COMMUNITY DEVELOPMENT DEPARTMENT
80 Columbia Avenue ♦ Marysville, WA 98270
(360) 363-8100 ♦ (360) 651-5099 FAX

Re: Quality Auto Center – *Tech Review 1*
PA22005

RE: Quality Auto Center, File# PA22-005
New Car Dealership
15233 Smokey Point Blvd. & Parcel # 31053300205300

PRELIMINARY SITE PLAN

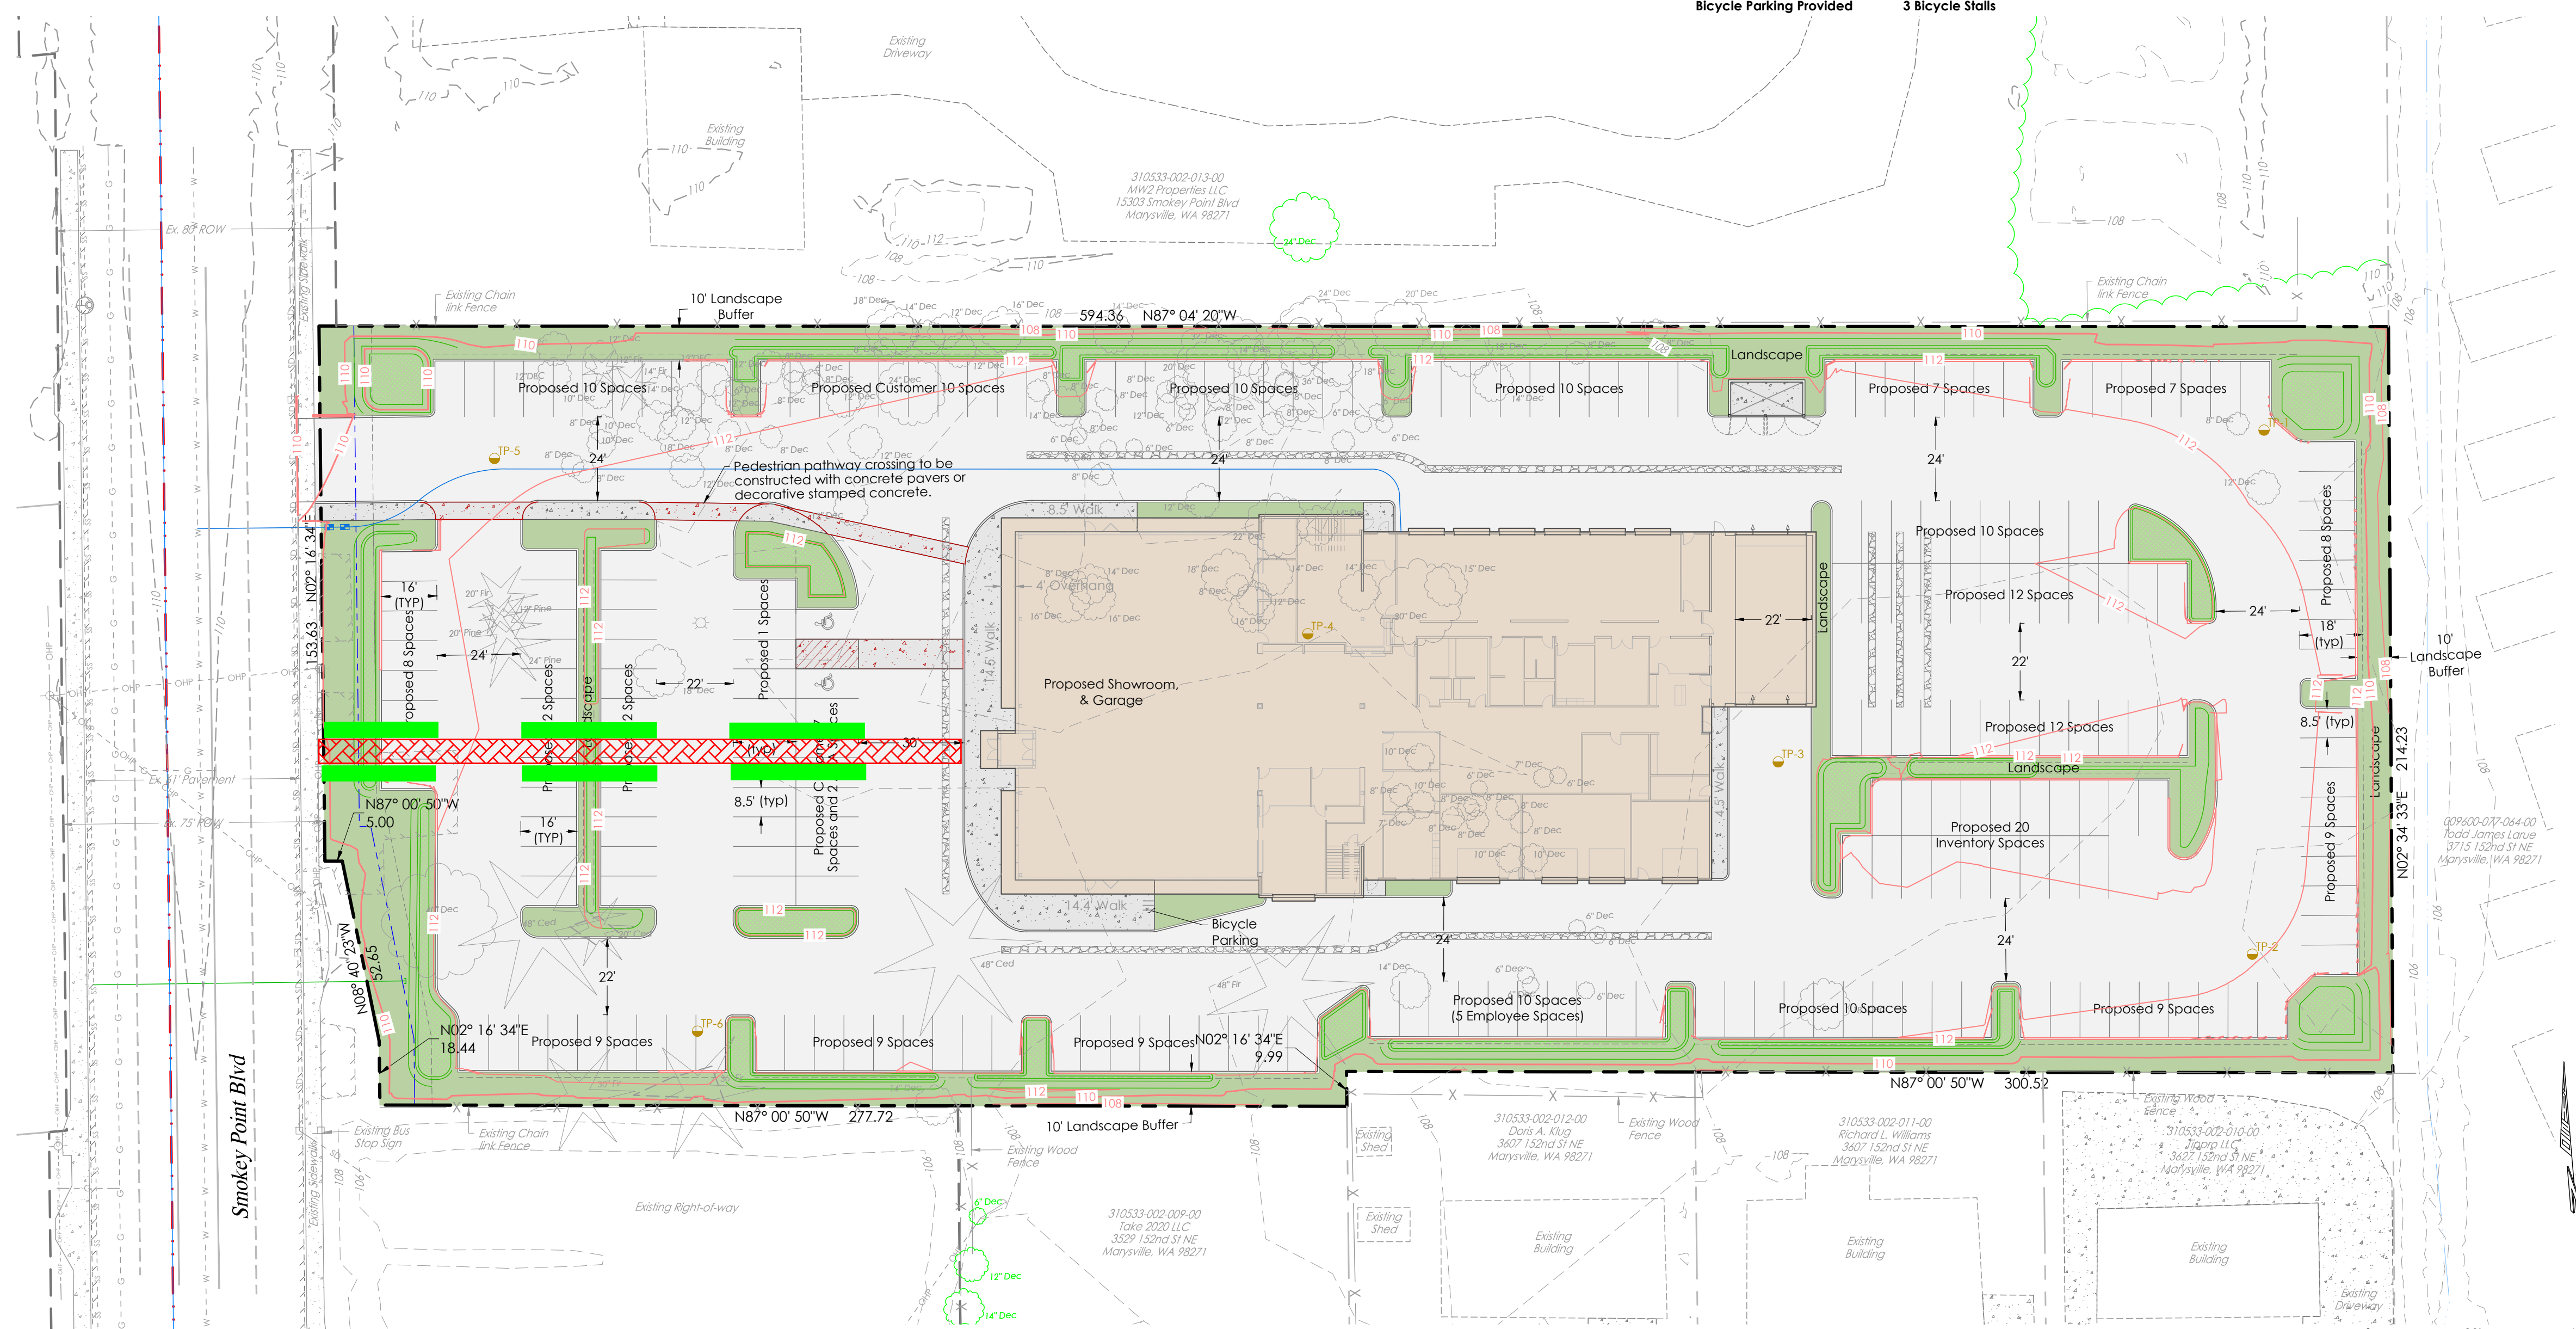
3. Sheet P1 shall be amended, as follows (see attached redlines):
 - a. The pedestrian connection shall be relocated to align with the front entry to the showroom to the sidewalk. Pursuant to [MMC 22C.130.050](#)(5)(c), the pedestrian pathway shall be constructed with decorative concrete and physically separated from vehicle traffic and maneuvering areas.

A minimum 5' landscape islands shall be provided on either side of the pedestrian pathway as it traverses through the proposed parking spaces and/or inventory lot.
 - b. Provide turning radii, demonstrating compliance with the following:
 - Turning radii - 20' (inside)
 - Turning radii (fire/solid waste) - 30.5' (inside) 46' (outside);
 - c. Amend SIGNS language to read as follows:
 - All signs ~~shall are to~~ comply with MMC ~~Chapter 22C.160 Signs~~~~22C.160.160(1)~~.
 - d. Under NOTES, remove notes d, e, f and g, and add the following notes:
 - Prior to civil construction plan approval, the applicant shall be required to demonstrate compliance with the applicable landscaping standards outlined in [MMC 22C.020.250](#)(4).
 - Prior to building permit issuance, the applicant shall be required to demonstrate compliance with the Site Design Utilizing Crime Prevention
